ROYAL CANADIAN AIR FORCE

EO 55-45-5
18 Jun 64

LIST OF SPECIAL INSPECTIONS

SAFETY HARNESS

Figure 1

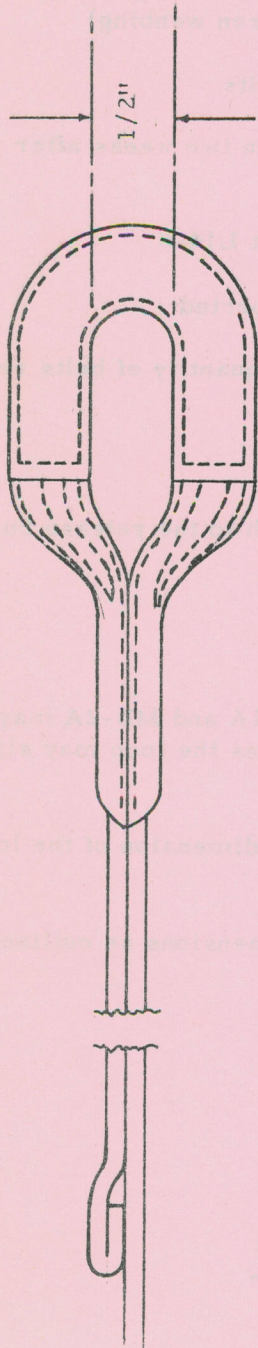
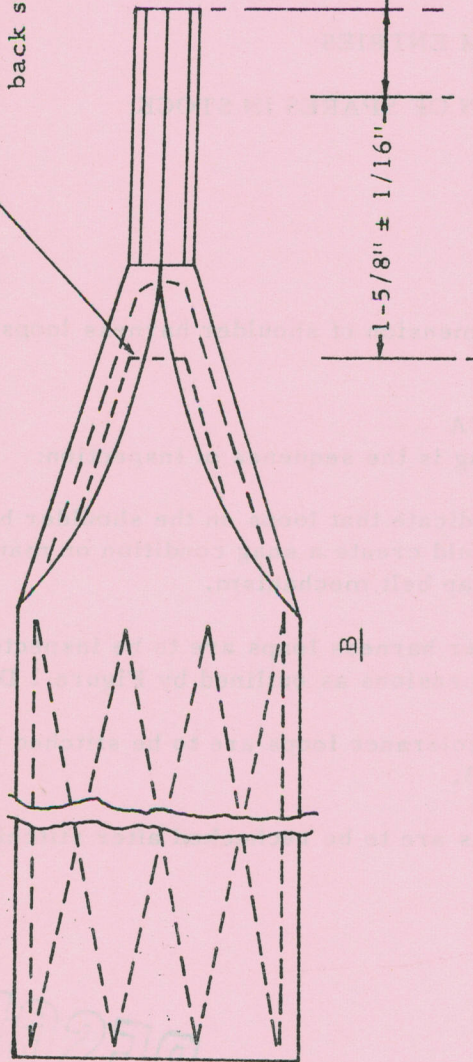
- (a) Reports indicate that loops on the shoulder harness type MB-1A and MB-2A may be oversize. This could create a snag condition on man seat separation as the loop may slip over the barrel of the lap belt mechanism.
- (b) All shoulder harness loops are to be inspected and the inside dimension of the loops must meet the dimensions as outlined by Figure 1 Details A and B.
- (c) All out of tolerance loops are to be stitched to the correct dimensions as outlined by Figure 1, Detail B.
- (d) Dimensions are to be rechecked after stitching.

Thread nylon Ref. 32B/383
 Spec MIL-T-7807, Size E, Class 1, Type 1
 Not less than 8 nor more than 10 stitches
 per inch. All ends of stitching shall be
 back stitched not less than 3/8"
